Stage 02: Industry Consultation

Grid Code

GC0068 Grid Code New & Revised Unit Data & Instructions

This proposal seeks to modify the Grid Code to capture changes to unit data and instructions resulting from functionality introduced with National Grid's new Electricity Balancing System.

Figure 1: Default arrangements where BM Unit deviates from zero MZT minutes after deviation to zero

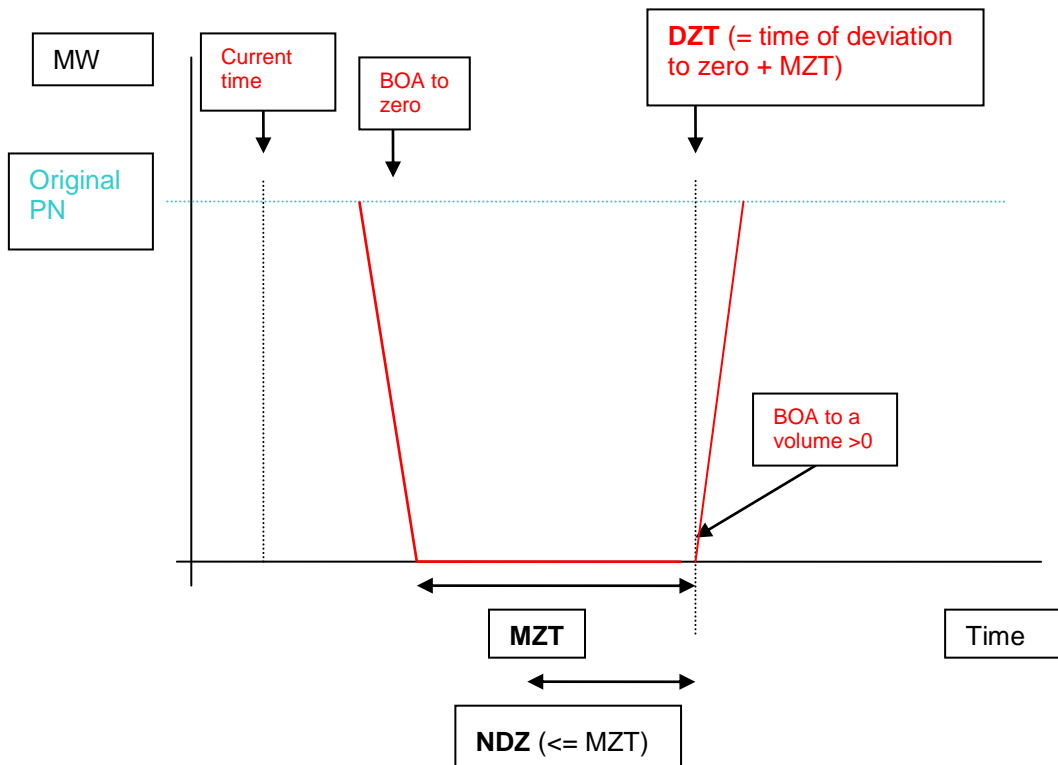
- 3.12 First to be outlined are the default arrangements that apply in the absence of any communications between the BM Participant and National Grid. This is illustrated in Figure 1 below. The Notice to Deviate from Zero (NDZ) cannot be greater than the Minimum Zero Time (MZT) as otherwise either the BM Participant would have to be notified of a subsequent deviation from zero before it had commenced operation at zero, or NDZ would effectively over-ride MZT. In this situation, the BM Unit would

deviate from zero at MZT minutes after the deviation to zero and National Grid would issue Bid-Offer Acceptances to effect this.

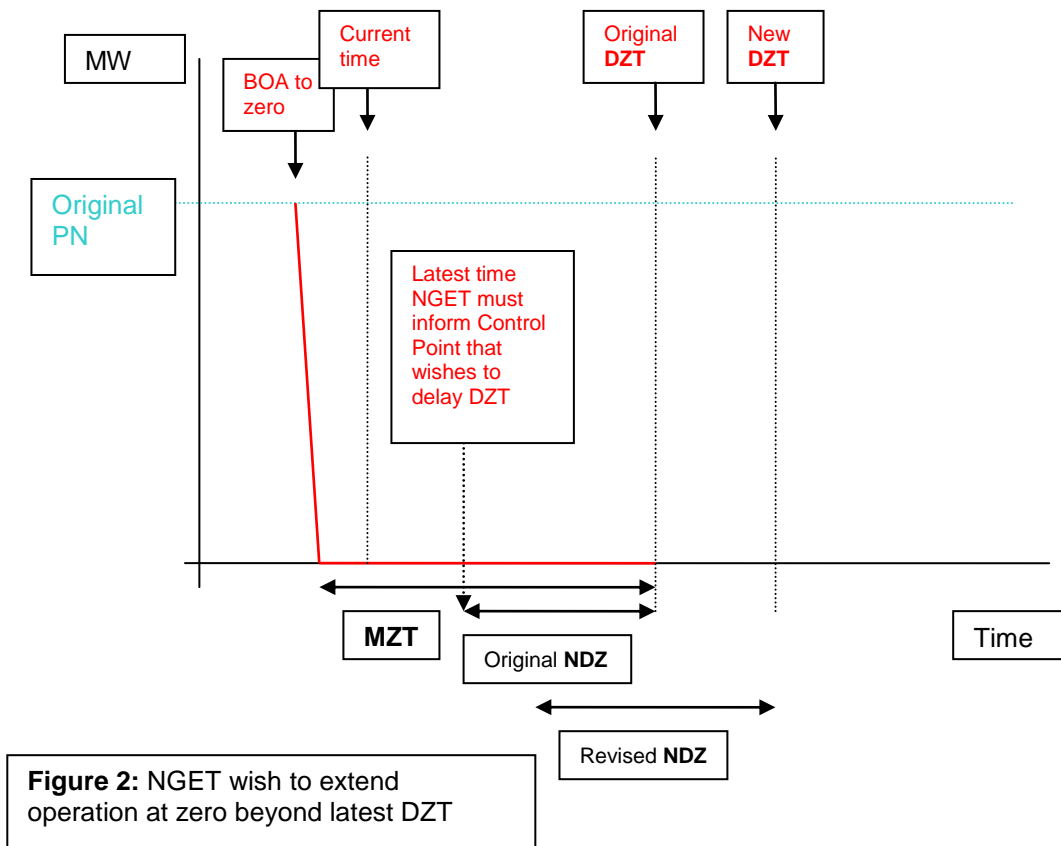
3.13 Secondly, the process by which National Grid would, if required, extend the operation at zero time of a BM Unit beyond the most recently established DZT is outlined. By no later than NDZ minutes prior to the DZT, National Grid would inform the BM Participant that the BM Unit period of operation at zero requires extending by communicating a new DZT. Once notified of this the BM Participant may re-declare the NDZ of the BM Unit such that it is applicable to the revised DZT, but that still allows the new DZT to be achieved. This is demonstrated in Figure 2 below.

Q8 Do you agree with the proposals to detail the arrangements that shall apply when deviating from zero?
